Model	N810	Volt/Hz	Date of Modification	Serial Number
Modified Article	Parts Catalog			
Reason for Modification	Parts catalog correction

MODIFICATION BULLETIN NO. 3

ISSUED ON: July 31. '93

Page 26

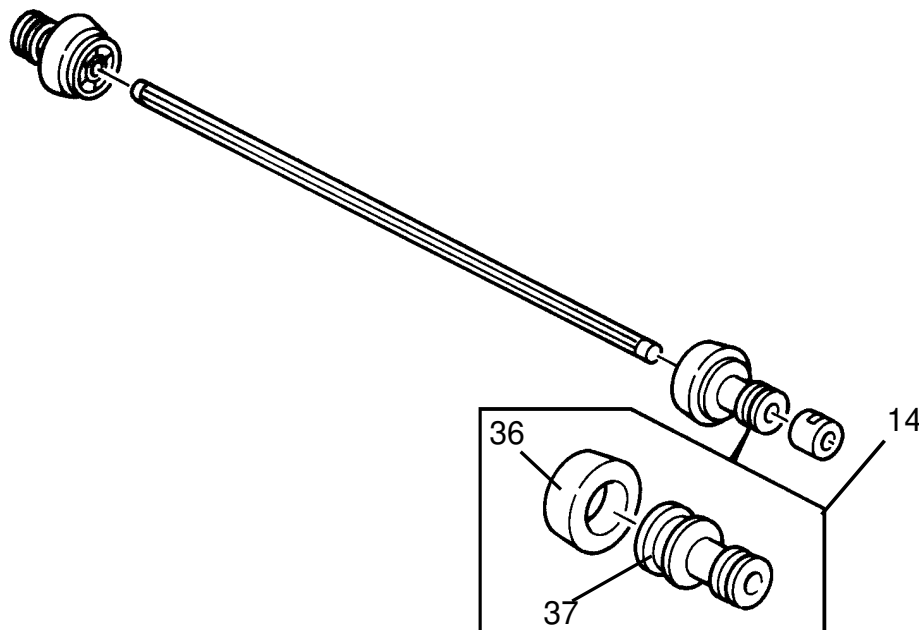
Correct the illustration of item 14 as shown below.

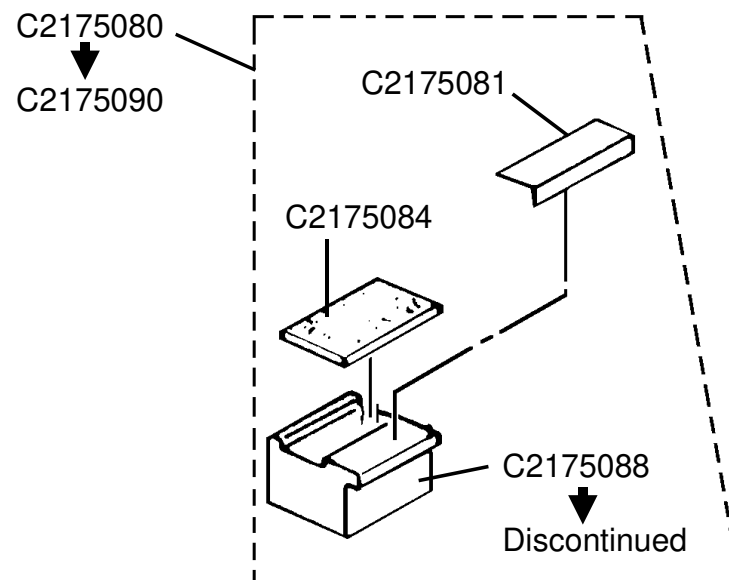
1. To feed paper more smoothly, the friction guide plate (C2175081) has been added from the 2nd production. Due to this modification, the configuration of the friction pad base (C2175088) has been changed. The friction guide plate has already been listed on the parts catalog.
2. To facilitate service, the new friction pad ass'y (# C2175090) including the friction guide plate (index 37, Page 13) has been registered instead of C2175080. The friction pad base is no longer provided as a service part.

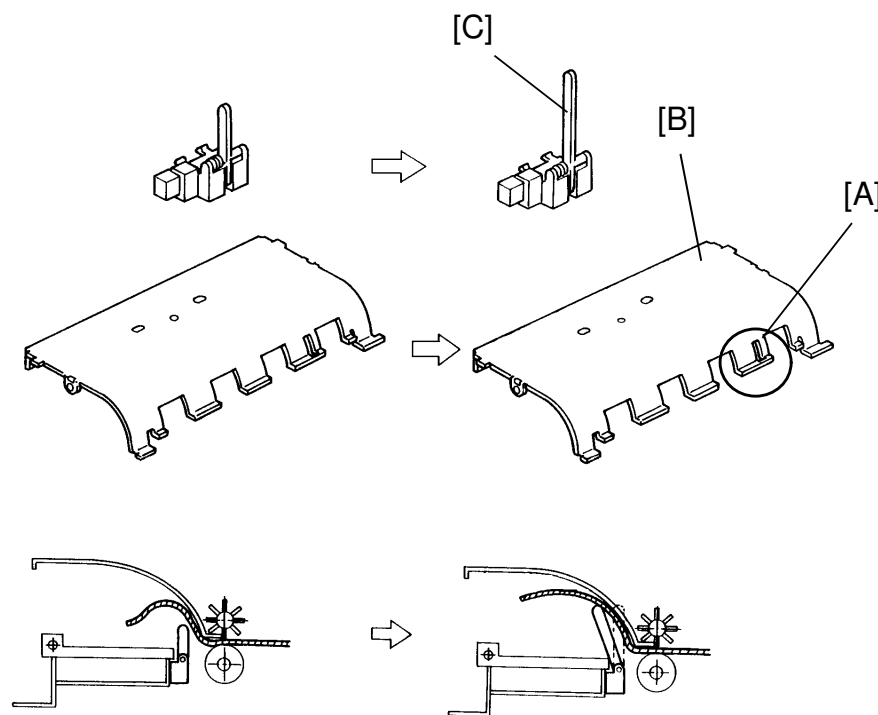
Even if the eject master is transported properly, it is possible that the master eject sensor will not detect the master when the master is transported over the sensor actuator.

To prevent this, a cutout [A] is added to the guide plate - exit unit [B], and the length of the sensor actuator [C] has been increased so that the sensor never fails to detect the eject master.

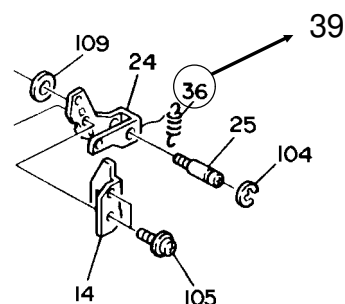
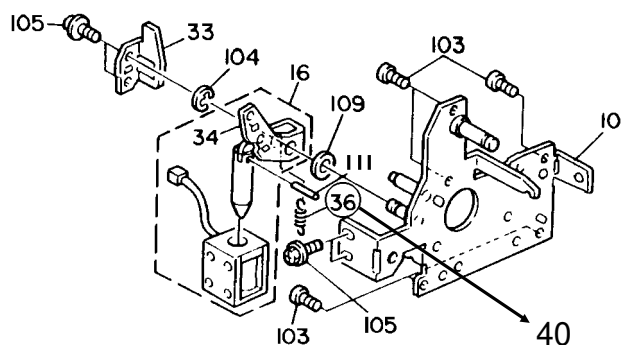
2. Correct the index number 36 of page 30 as shown below.

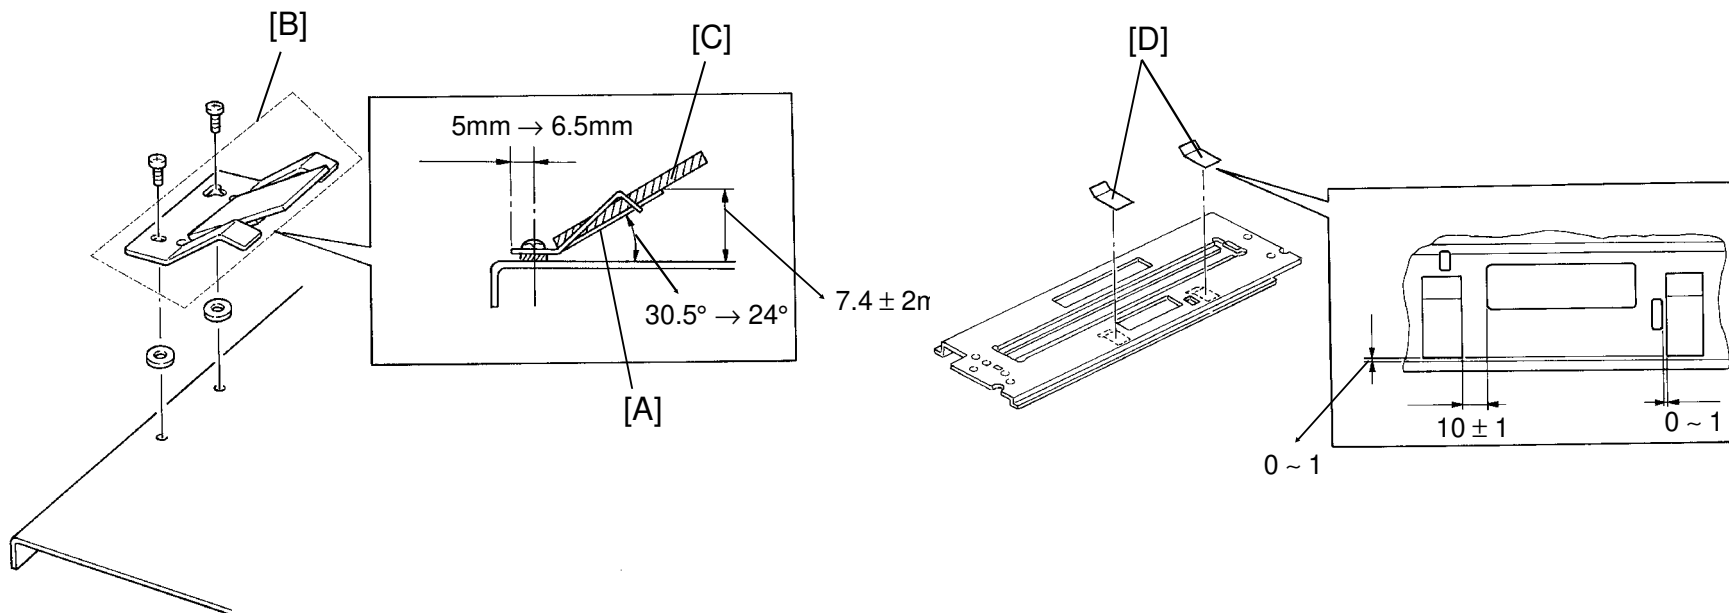
1. To ensure smooth original feed, the angle of the separation spring plate [A] has been changed from 30.5° to 24°. Also, the position of the plate [A] has been shifted by changing the screw hole positions.
2. To facilitate service, the ADF friction pad ass'y [B] which includes the ADF friction pad [C] has been registered as a service part instead of the separation spring plate [A].
3. New mylars (original guide mylar, index 19) [D] have been installed on the upper guide plate [D] to prevent double feed. These mylars push the second original up to ensure the original registration sensor can detect a gap between the 1st original trailing edge and 2nd original leading edge. This prevents two original from being fed continuously.

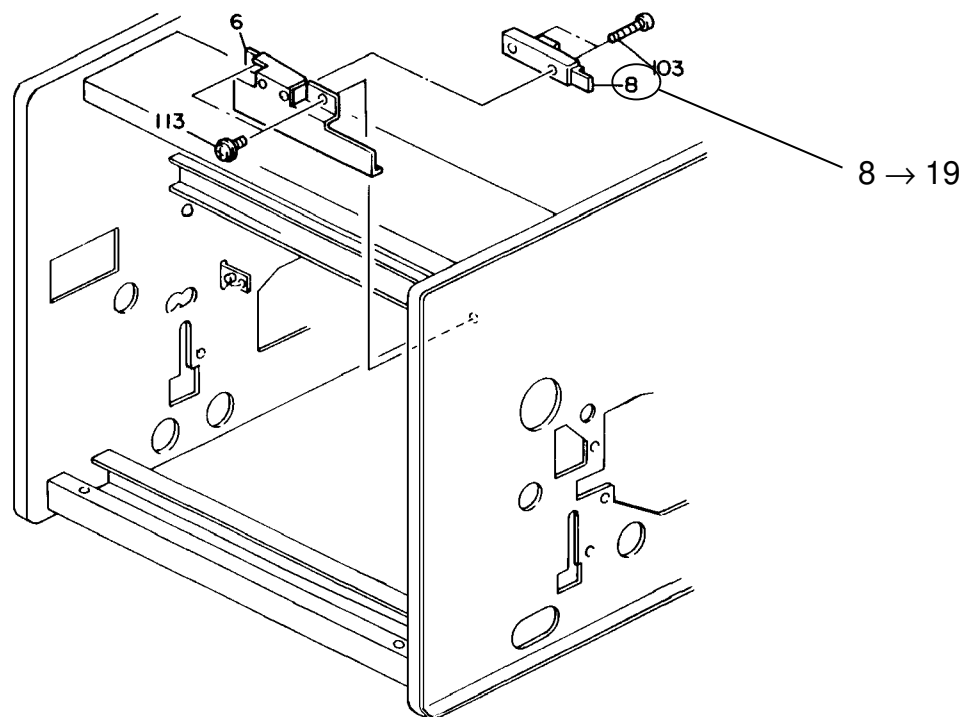
Due to parts standardization, the drum master sensor (index No. 8) has been changed to the one used for the paper exit sensor (index No. 19).

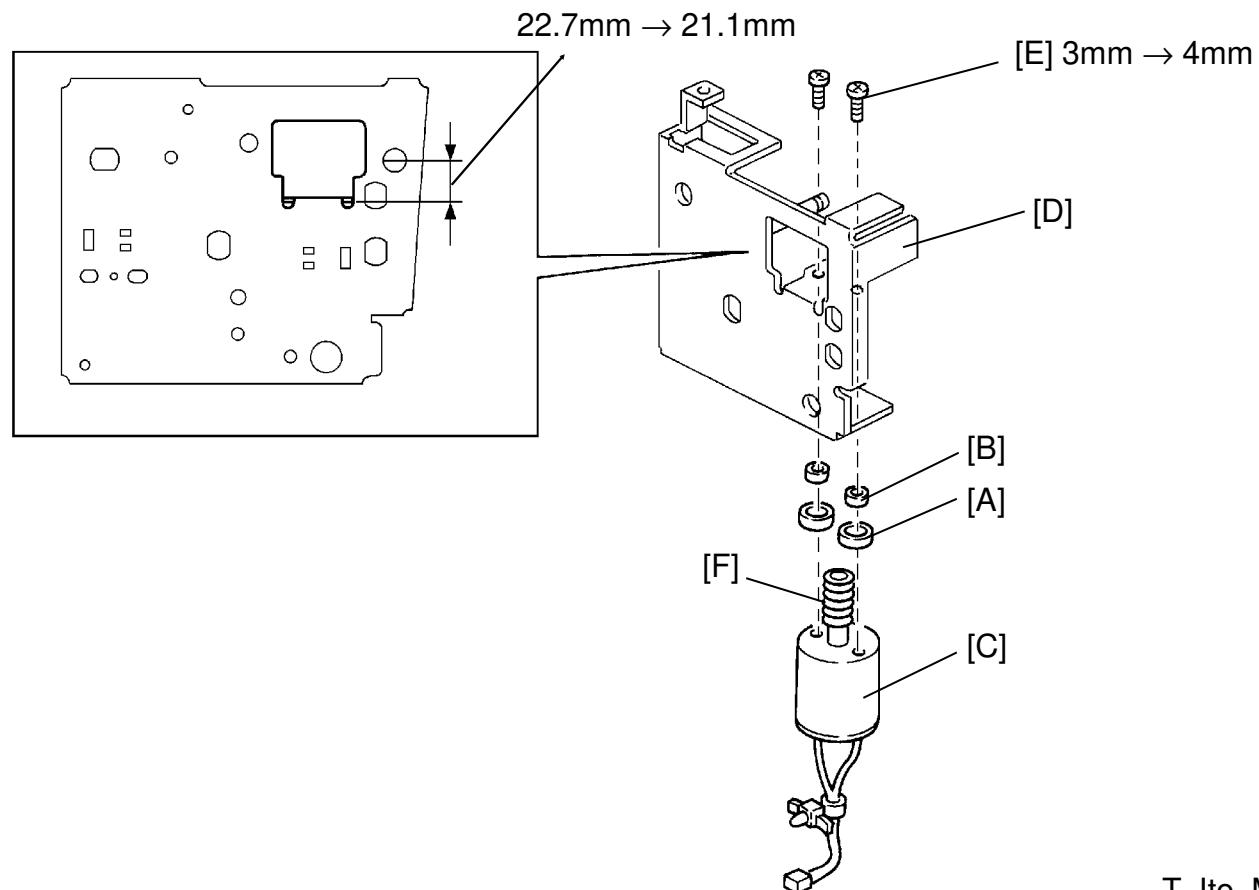
To reduce noise, two insulators [A] and bushings [B] have been inserted between the pressure motor [C] and the right side plate. [D]

Due to this modification, the two screws [E] fixing the motor have been changed from 3mm to 4mm. Also, to keep the relation of the position between the pressure plate gear and the worm gear, [F] the configuration of the right side plate has been changed.

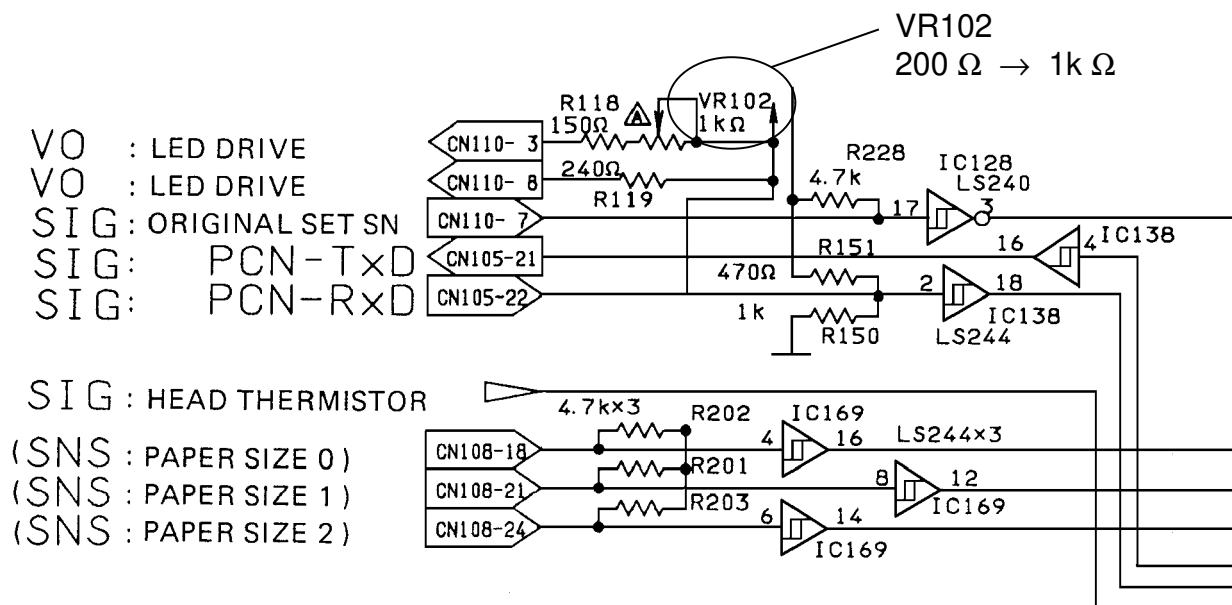
To extend the range of the sensor adjustment, a variable resistor on the main board has been changed from 200 Ω to 1K Ω . The part number of the main PCB remains the same.

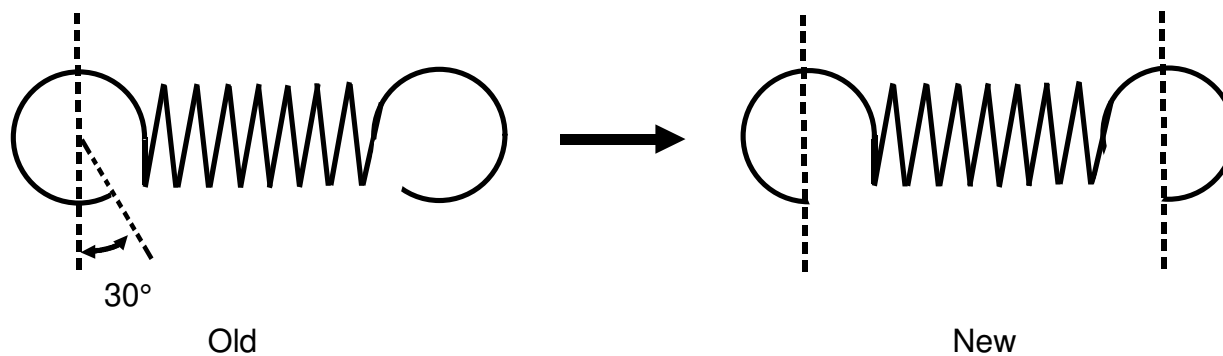
To hook the spring on the pressure plate arm more easily, the configuration of the pressure plate spring has been changed as shown below.

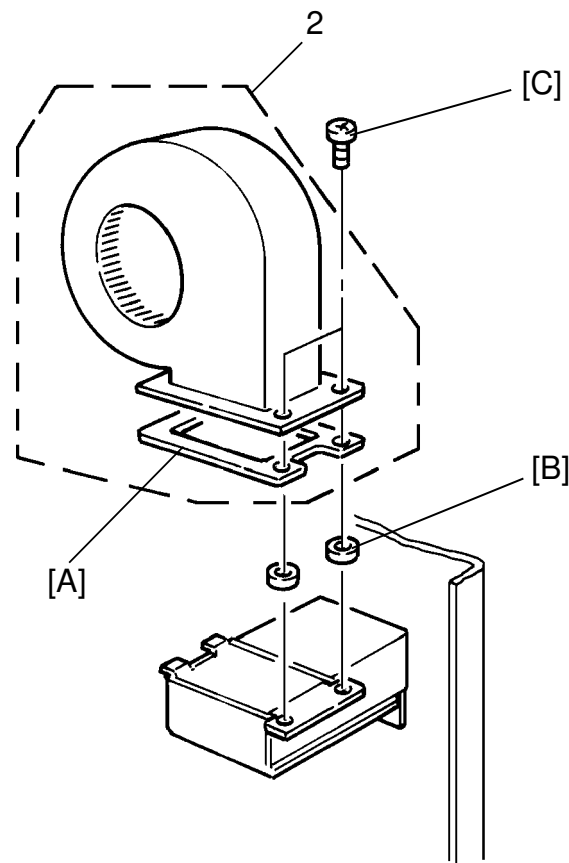
To reduce noise, a rubber base [A] and two bushings [B] have been added to the air knife motor. Due to this modification, the two screws [C] fixing the motor have been changed from 6mm to 8mm.

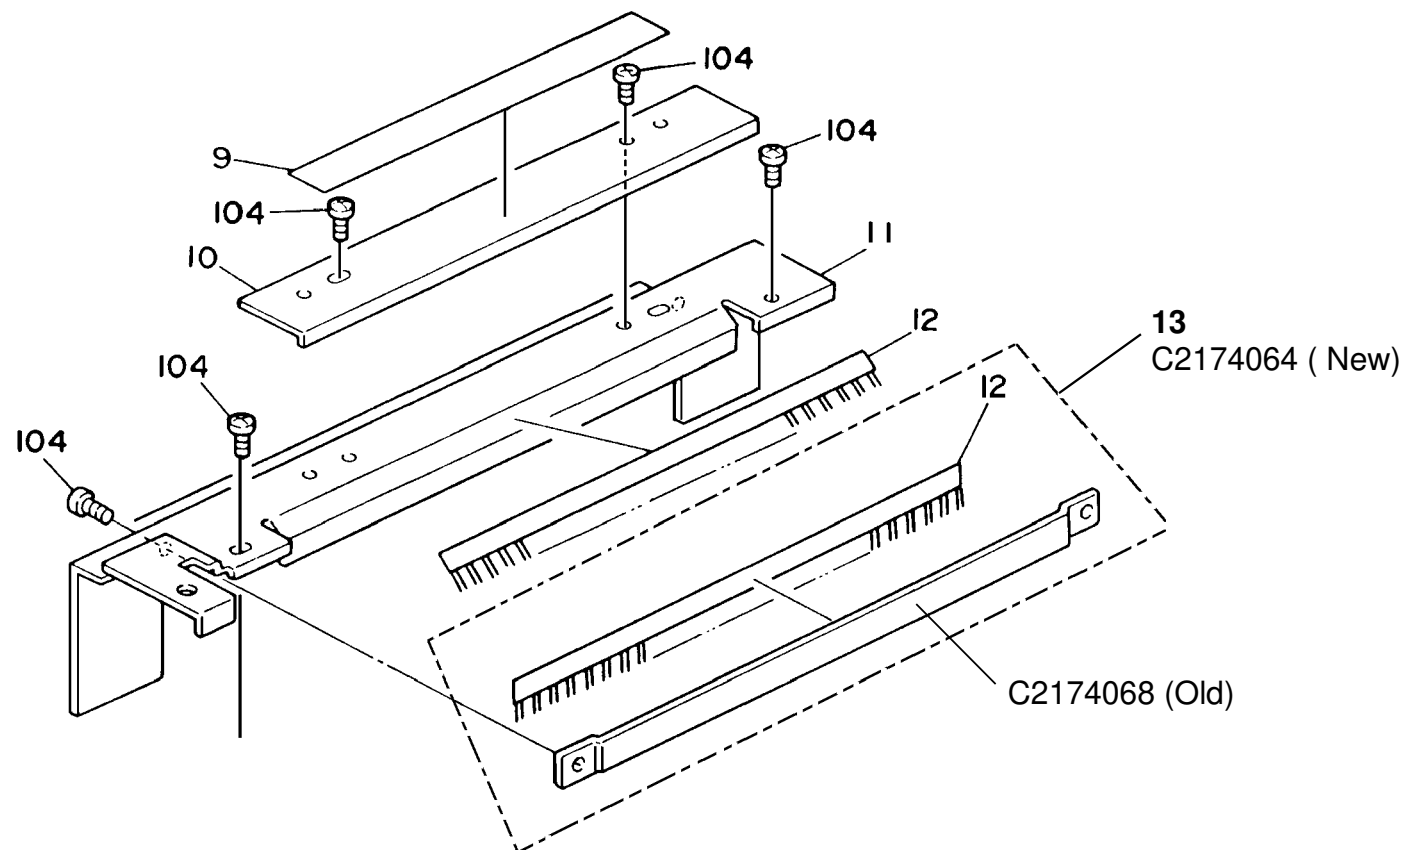
To facilitate service, the Antistatic Brush Ass'y (C2174064) is now provided as a service part instead of the Inner Cover (C2174068), because in the field it is difficult to stick the brush to the correct position of the inner cover.

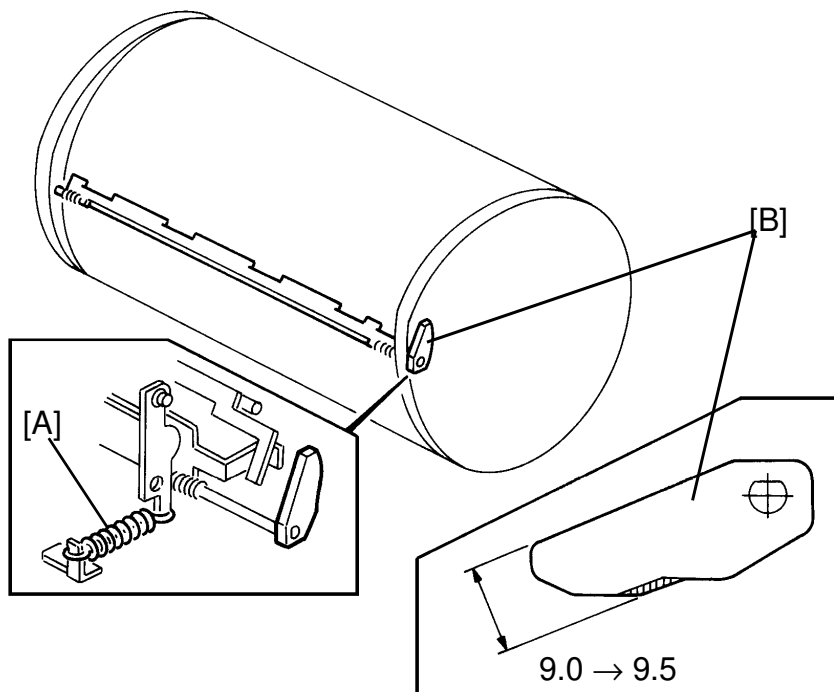
To minimize creasing of the master around the drum, the tension of the two springs that apply tension to the tension roller has been increased. To ensure proper master clamber opening after the tension is increased, the shape of the Clamber Cam [B] has been changed.

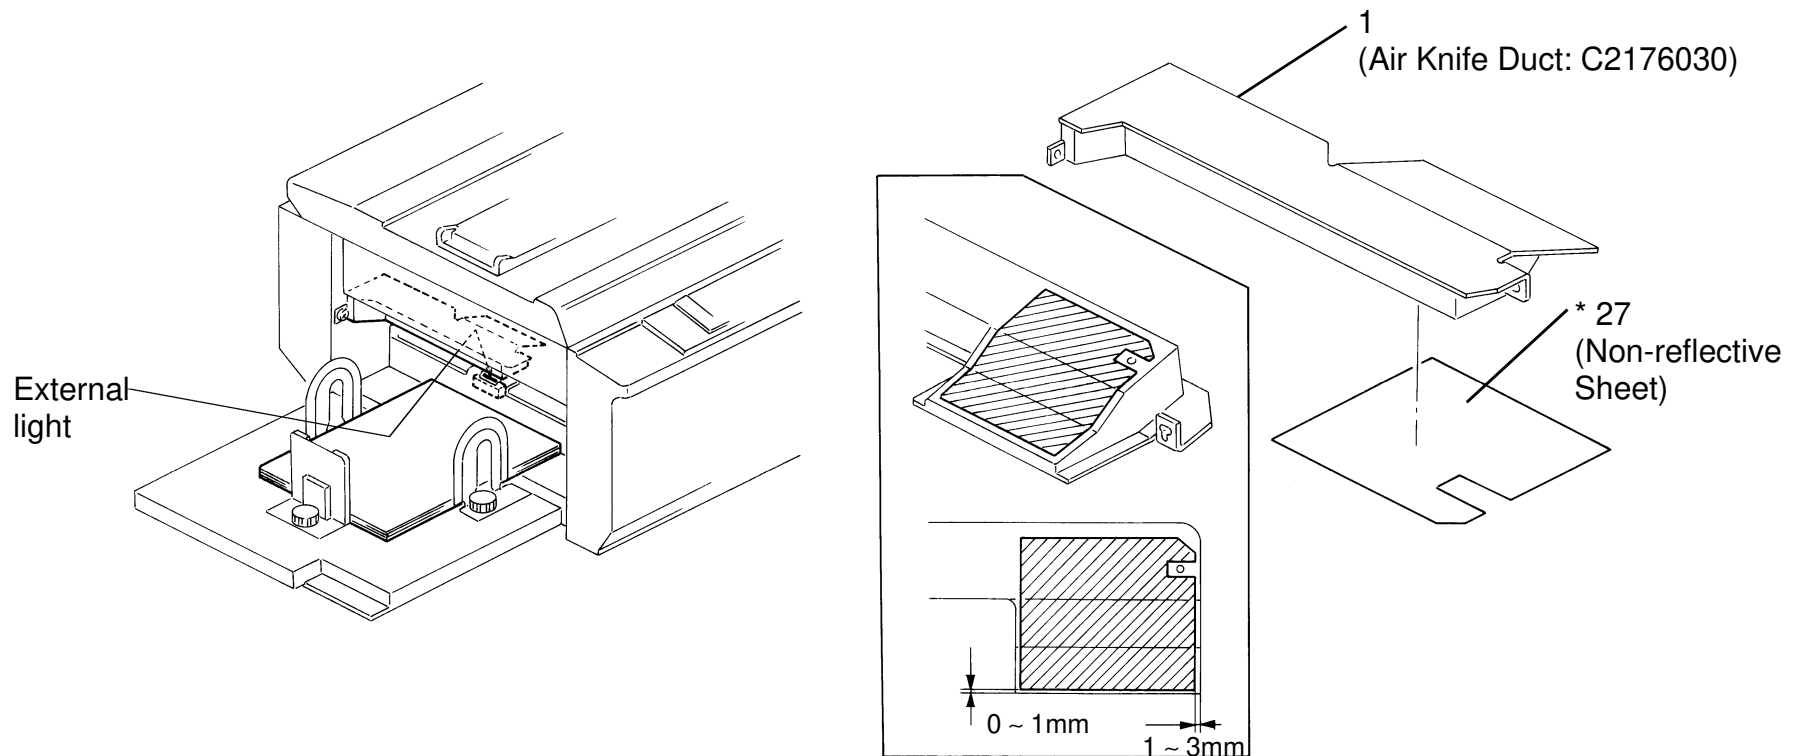
The exit sensor may detect a paper exit jam mistakenly when external light exposes the sensor as shown below. To minimize this, a sheet which has a light non-reflective material has been stuck on the air knife chamber.
